TAIL LAMP WIRING /1973 MODELS XL,XLCH,

Rear Tail Lamp Wiring Clip and License Plate Mounting Washers

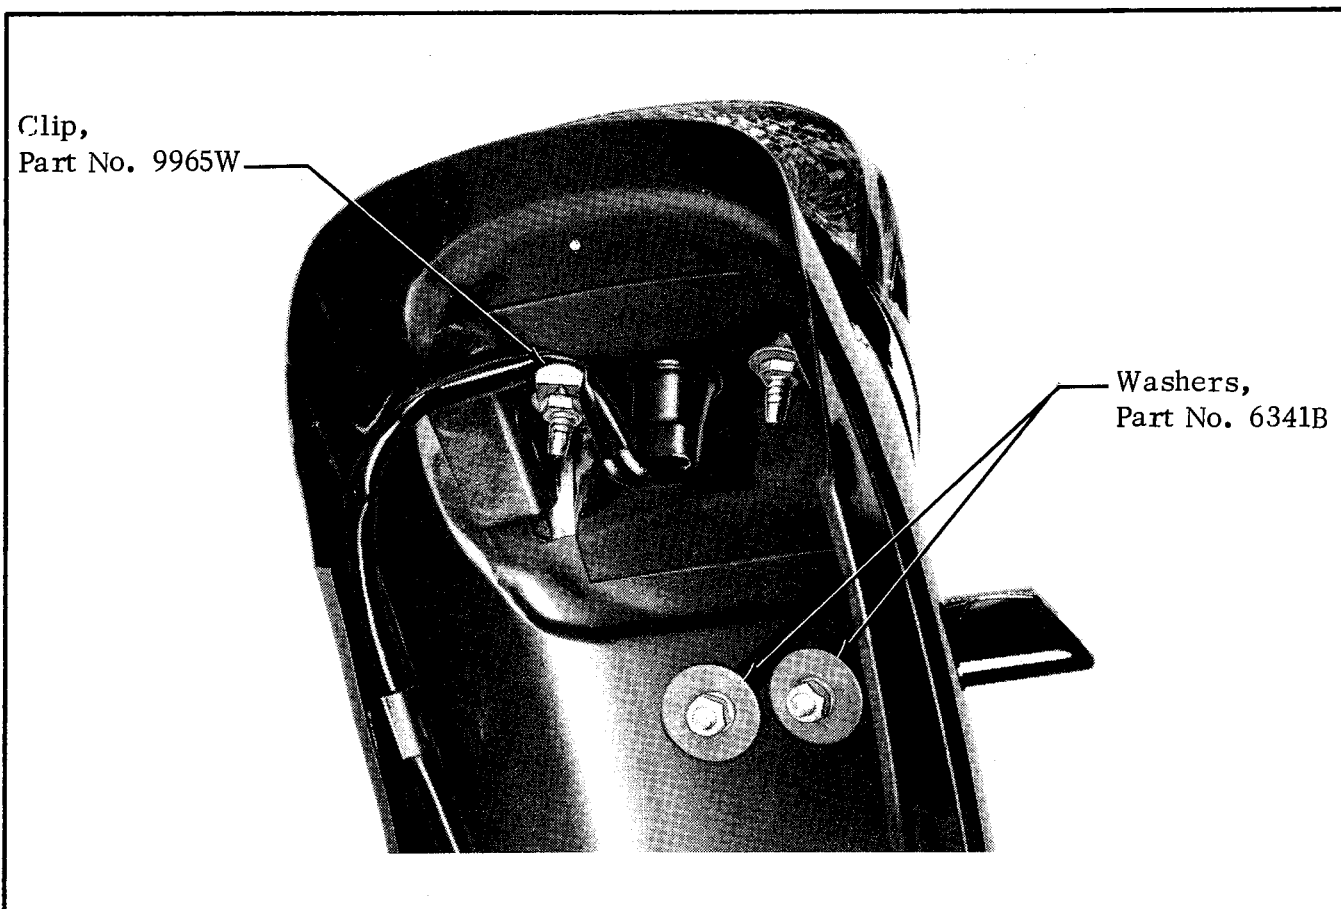
Initial production of 1973 Models XL/XLCH-1000 motorcycles were produced without a retaining clip to hold the wires against the fender near the tail lamp bulb socket.

This condition allows the wires to loop outward into the tirewell, possibly contacting the tire and rubbing off the insulation or tearing the wires when the wheel is adjusted to the rear position.

Removal of the wire insulation or tearing of wires would result in a short circuit or open circuit making the tail lamp and/or stop lamp inoperative. This would constitute a traffic hazard because of the absence of a stop signal and/or tail lamp illumination to warn following traffic.

Note: At time of vehicle inspection, check to see that 1-1/8 dia. flat washers, part No. 6341B, are installed underneath license plate bracket nuts as shown in the illustration.

In compliance with the National Motor Vehicle Safety Act, this has been declared a safety defect and will require that you install retaining clip, part No. 9965W, on the left side tail lamp mounting stud of all affected vehicles, to hold the tail lamp wires in place (see illustration).

These washers have been added for later 1973 production to reinforce the bracket mounting.
